REC-11-04

Working Party on Pollution and Energy

Retrofit Emission Control Devices (REC)

Draft rev.00 Version REC-11-04 dated 23.05.2011

Figure 1.1:

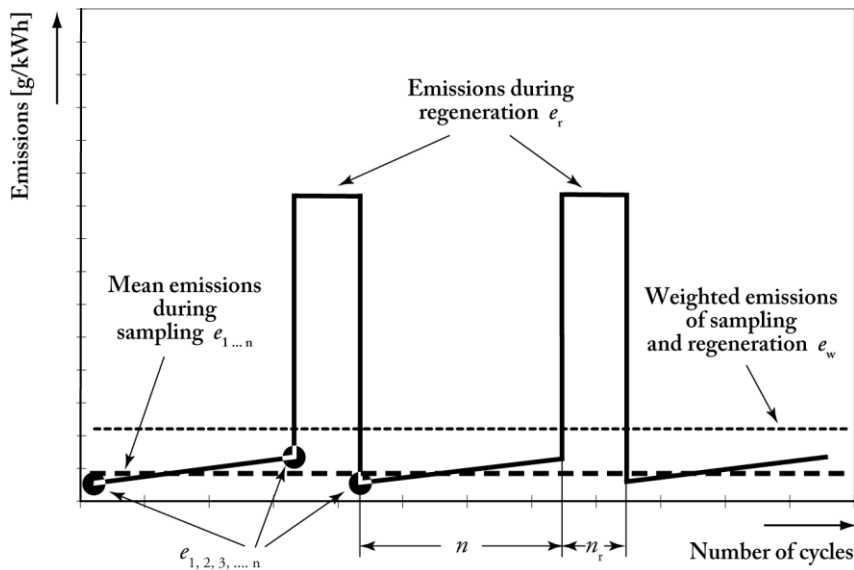
Comment [DB33]: Is this the right word?

Comment [DB34]: Check the referen

Test sequence for **particulate reduction-REC**

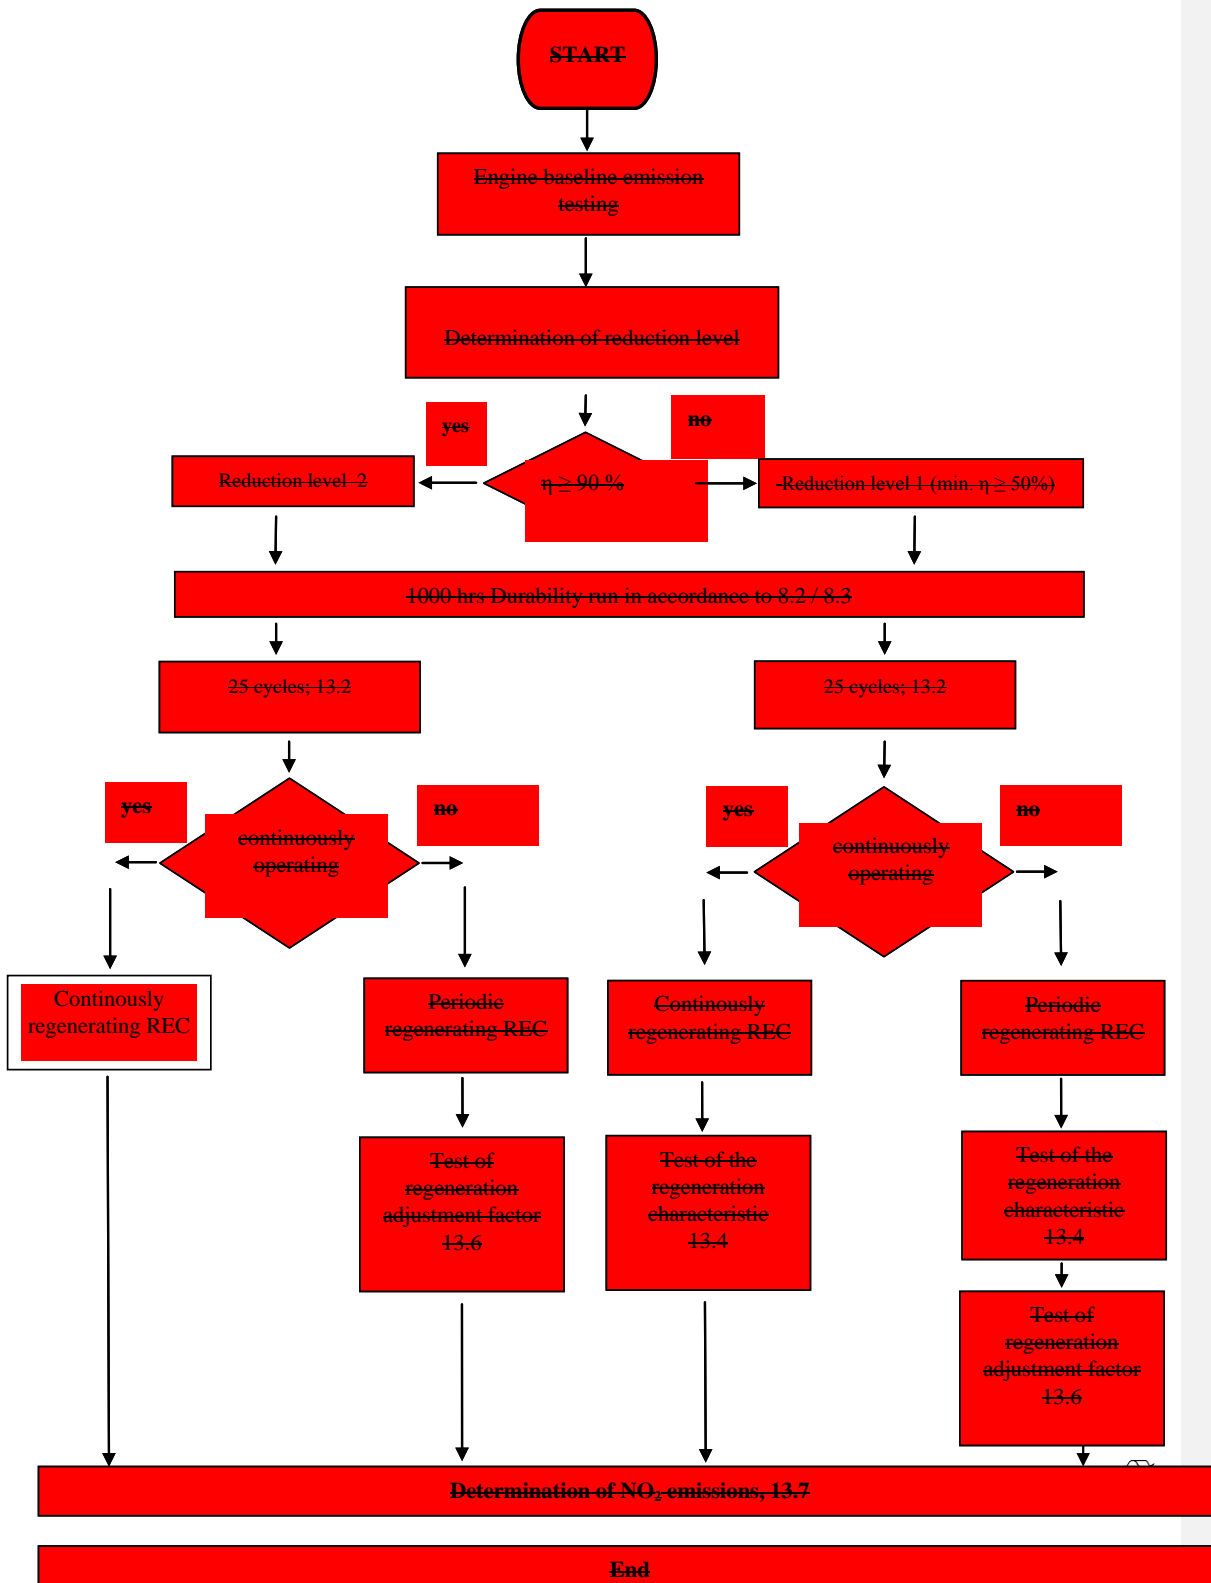
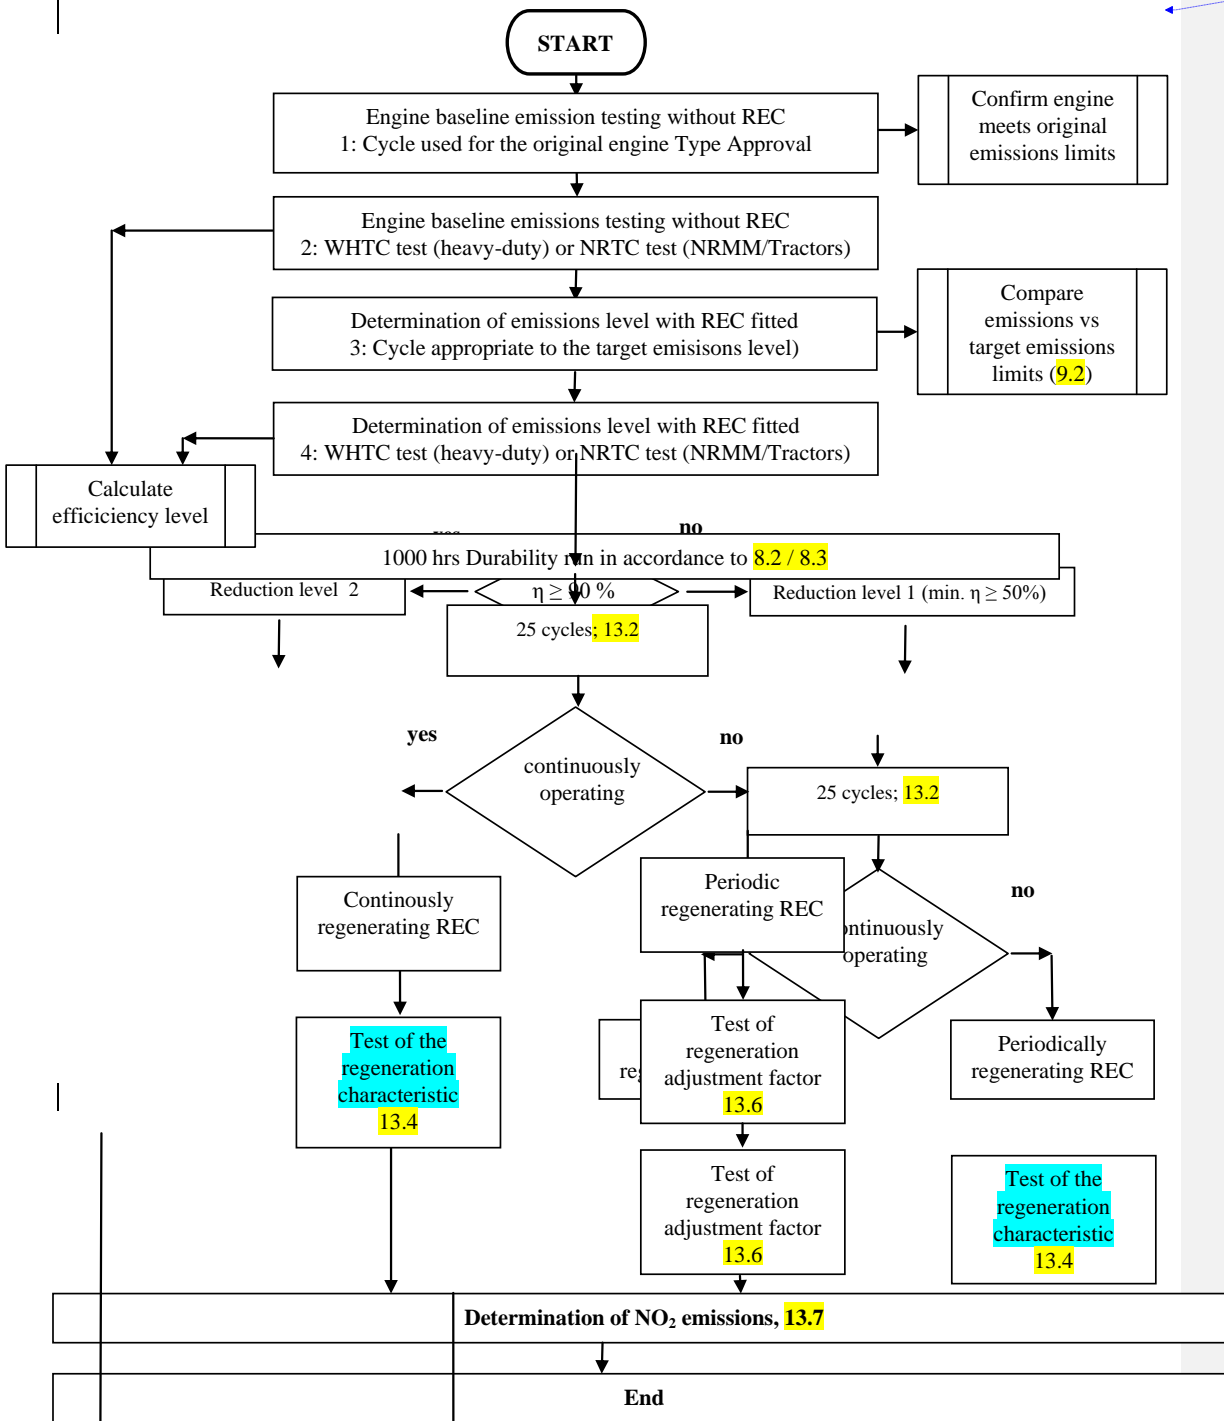
Comment [JMY40]: Can PM & NO_x reduction be combined in 1 flowchart? Chart to be reviewed when rest of document finalised.
